M54 to M6 Link Road

**8.8 P(A) Statement of Common Ground
with Environment Agency**

STATEMENT OF COMMON GROUND

This Statement of Common Ground has been prepared and agreed by (1) Highways England Company Limited and (2) Environment Agency.

Figure 1

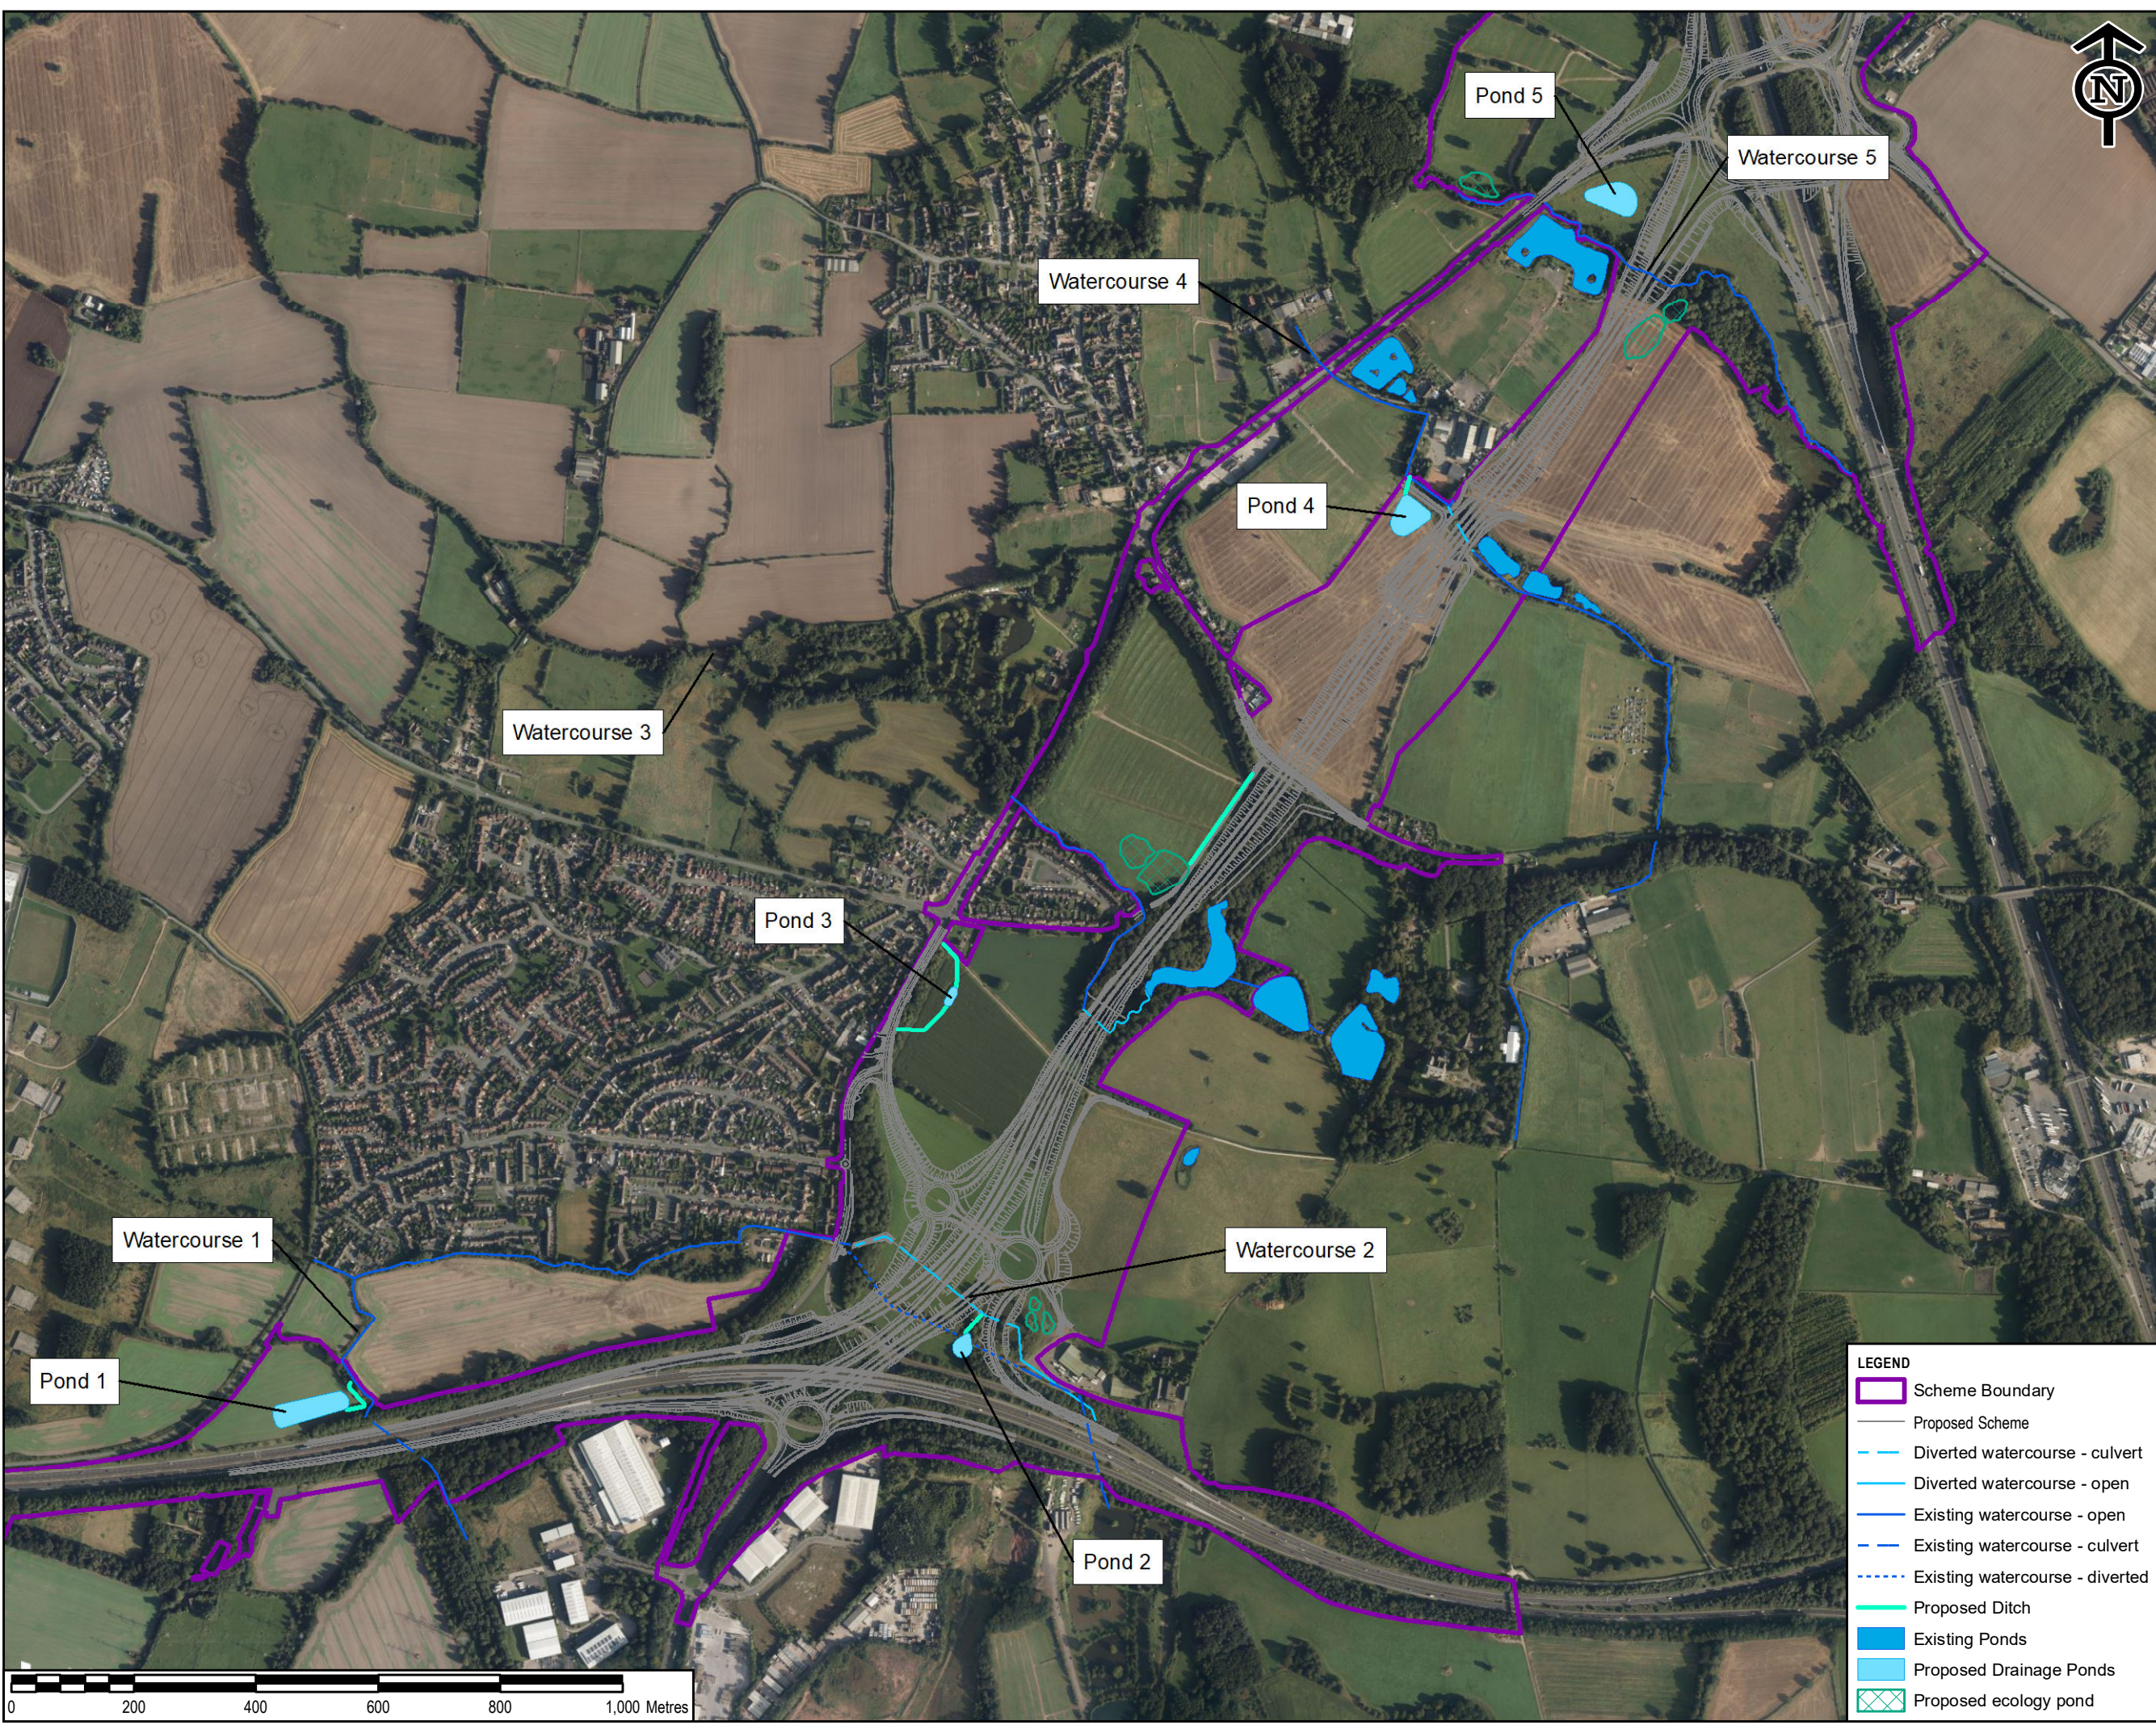
ES Chapter	Paragraph Reference	Sub-section	Environment Agency Comment	Highways England Response	Status	Agreement likely?	
						APP? ¹	IP?
				<p>Agency to welcome this rather than conventional drainage options.</p> <p>The proposed operational phase surface water drainage strategy is described in Appendix 13.2: Drainage Strategy [APP-201/6.3] and summarised in paragraphs 13.8.11 to 13.8.20 of Chapter 13 of the ES [APP-052/6.1]. Appendix 13.3: Assessment of Routine Road Runoff and Accidental Spillage Risk (HEWRAT) [APP-202/6.3] presents full details of the water quality risk assessment that has been carried out, which is summarised in paragraphs 13.9.57 to 77 of Chapter 13 of the ES [APP-052/6.1]. Appendix 13.4: Water Framework Directive Assessment [APP-203/6.3] also includes consideration of surface water drainage proposals and the assessment carried out.</p> <p>The previous estimates of the new ditchcourses failed to include the ditch to Watercourse 1 and thus the total length is in fact 483 m of new ditchcourses as opposed to 408 m reported in the ES and associated appendices. This includes 75 m of ditch to Watercourse 1, 32 m to Watercourse 2, 280 m to and from Pond 3 to Watercourse 3, and 96 m to and from Pond 4 to Watercourse 4. In addition, it should be noted that the</p>

ES Chapter	Paragraph Reference	Sub-section	Environment Agency Comment	Highways England Response	Status	Agreement likely?	
						APP? ¹	IP?
				<p>Scheme will also provide new channels for Watercourse 2 (where it is diverted) and Watercourse 3 (due to the relocation of the impoundment to Lower Pool), which will also be designed to improve upon the current channel form, with the estimated lengths provided in the WFD Summary presented in Appendix B.</p> <p>The proposed road drainage networks 5, 8 and 10 (i.e. to Watercourses 2, 3 and 4, respectively) are not reliant on the proposed ditchcourses to provide treatment of highway runoff. Treatment of highway runoff from road drainage network 3 (to Watercourses 1) will primarily be from the proposed wet pond. However, to ensure adequate treatment is provided the proposed ditchcourse from Pond 1 is required to provide some treatment. Overall, as the flow within these ditchcourses will come from highway surfaces via a treatment train, water quality will be influenced by the type and range of chemical compounds that may be found in highway runoff. However, the proposed ditchcourse will still provide biodiversity benefits, and are preferred to discharging water from the treatment pond via a pipe and new engineered</p>

Figure 4-3: Watercourse 5 crossing: setting, and representative images

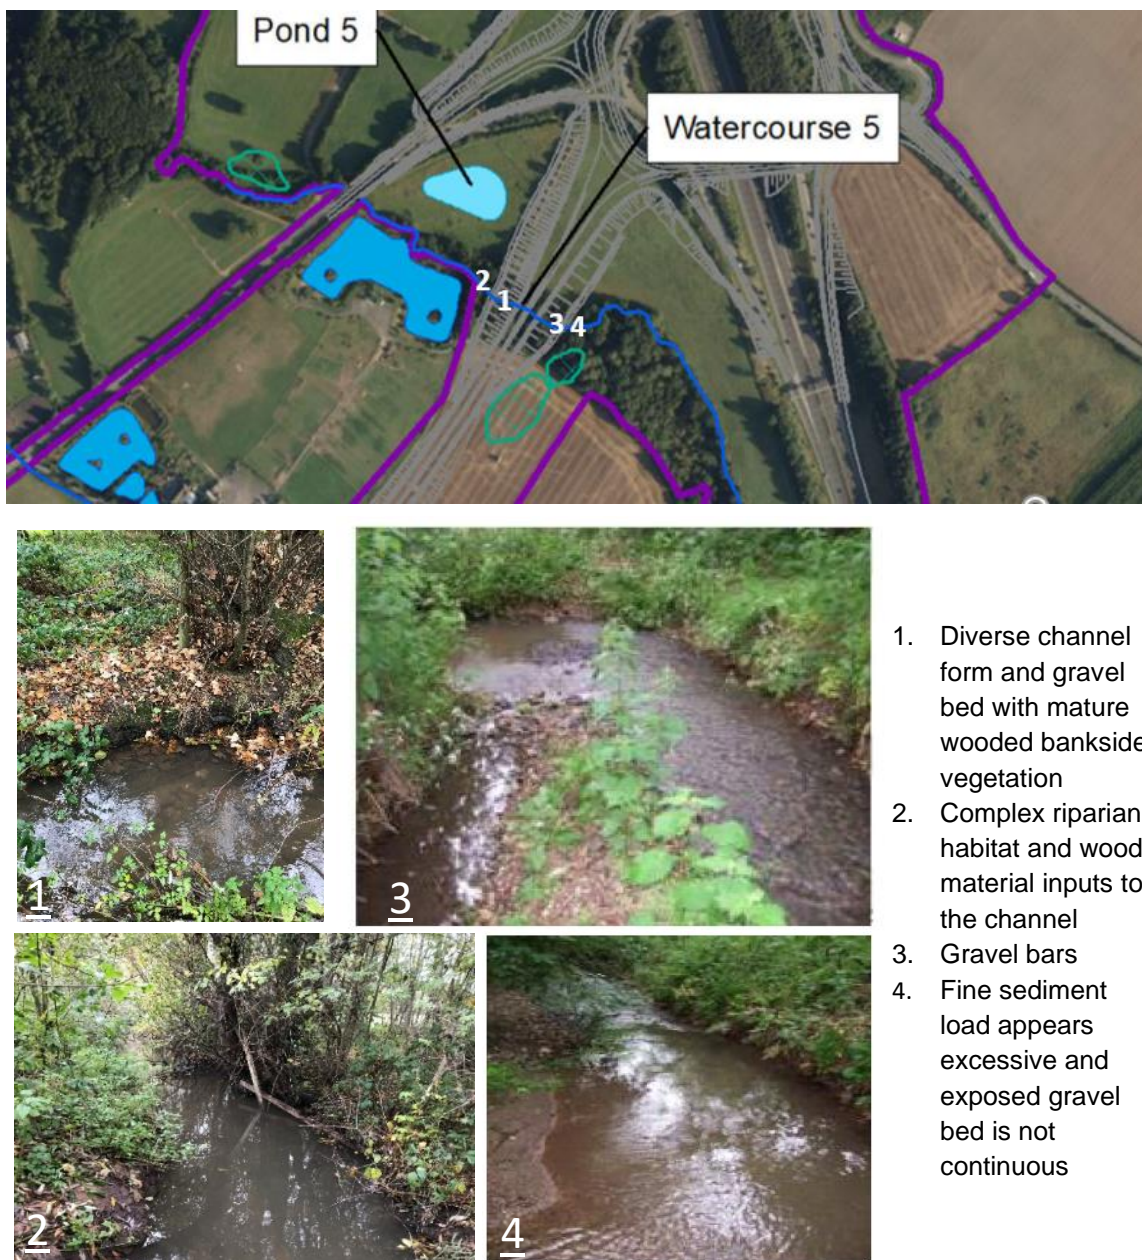
ES Chapter	Paragraph Reference	Sub-section	Environment Agency Comment	Highways England Response	Status	Agreement likely?	
						APP? ¹	IP?
				<p>The preliminary design for this structure was submitted as part of the draft DCO sent to the EA on 7 December 2020 for information.</p> <p>As set out in Para 4.3.5 of the WFD summary report the impact on aquatic habitat would be as a result of the semi-enclosure of the currently open channel resulting in shading. There is also the potential for indirect habitat impacts resulting from changes in hydraulic and sedimentary flow conditions resulting from the floodplain narrowing and loss of riparian woody material inputs from the channel, but these would be minor.</p>			
Appendix 13.4 Water Framework Directive of the ES [APP-203/ 6.3]	Section 5.3 Operation	Impact on Latherford Brook	<p>The current functional width of the Latherford Brook is 17 m so this would result in a loss of functional planform for the river and this is not mentioned in this section.</p> <p>Following the Highways England response provided, the EA is comfortable that the bridge span provided is appropriate.</p>	<p>It is unclear what is meant by 'functional width.' If it is referring to function in terms of river channel movement laterally across the floodplain then Highways England disagrees that the river is naturally sufficiently powerful to cause planform change in response to secondary currents at this location. Paragraphs 6.1.30 to 6.1.34 of the report (as stated above) describe the river corridor and why a clear-span of 10 m is considered appropriate. This solution has been reached in the context that wider bridge spans are increasingly expensive, complicated to build and</p>	Agreed	Agreed	Agreed

ES Chapter	Paragraph Reference	Sub-section	Environment Agency Comment	Highways England Response	Status	Agreement likely?	
						APP? ¹	IP?
				<p>have a wider footprint. A compromise has been proposed that maintains the primary channel with minimal modification to channel geometry balanced against cost, land take and engineering considerations. Although not described in the WFD assessment, hydraulic modelling to determine flood risk changes as a result of this crossing of the Latherford Brook has been undertaken and is presented in Annex B (Hydraulic Model Report) of Flood Risk Assessment (Appendix 13.1 of the Environmental Statement [TR010054/APP/6.3]). The Flood Risk Assessment was provided to Environment Agency and LLFA for review on 20th November 2019.</p> <p>Hydraulic modelling showed that a structure of around 3 m by 3 m would be sufficient to convey flows. A 10 m clear span is considerably greater than a minimum of 3 m. The proposal for a 10 m clear-span bridge is therefore being recommended to maintain the river corridor for the primary channel for hydromorphological and ecological reasons (e.g. in comparison to a culvert of standard dimensions required to manage flood risk only). It is also considered that a 10 m width would</p>

ES Chapter	Paragraph Reference	Sub-section	Environment Agency Comment	Highways England Response	Status	Agreement likely?	
						APP? ¹	IP?
				avoid development of the vena contracta effect through the bridge orifice, thereby avoiding natural erosion downstream.			
Appendix 13.4 Water Framework Directive of the ES [APP-203/ 6.3]		Hydromorphology	<p>The reports provided have an insufficient hydromorphological assessment (considering all the elements of hydro-morphological quality elements). Flow impacts are only one element of hydromorphology. Culvert design does not mitigate the negative impacts of culverting on the loss of natural bank conditions, marginal vegetation, and sediment supply from banks etc.</p> <p>The Environment Agency are not able to find any separate documents related to morphological assessment. However, the fish survey shows the availability of the fish in this minor watercourses and it proves some morphological value exists in this watercourses, so the impacts of the scheme on this element need to be assessed.</p>	<p>The impact of culverting would be mitigated by the design of the culvert (to reduce adverse impacts on the hydromorphology of the watercourse and channel continuum), the design of diversions/enhancements to provide enhancement on existing modified channels, and by the creation of new drainage ditchcourses (and ecological ponds) (to compensate for the loss of riparian habitat, shading of existing channels etc.).</p> <p>In general, due to the small size of watercourses that would be culverted by the Scheme there will be limited downstream transportation of coarse sediment. Although the channel of Watercourse 4 downstream of the A460 includes alternating (embryonic) lateral gravel bars (suggesting that flows are capable of transporting small diameter gravels), the location of the proposed culvert is between two sets of ponds near Brookfield Farm, which will significantly reduce the downstream transport of coarse material. Therefore, it is not expected that there would be any significant interruption of sediment</p>	Agreed	Agreed	Agreed
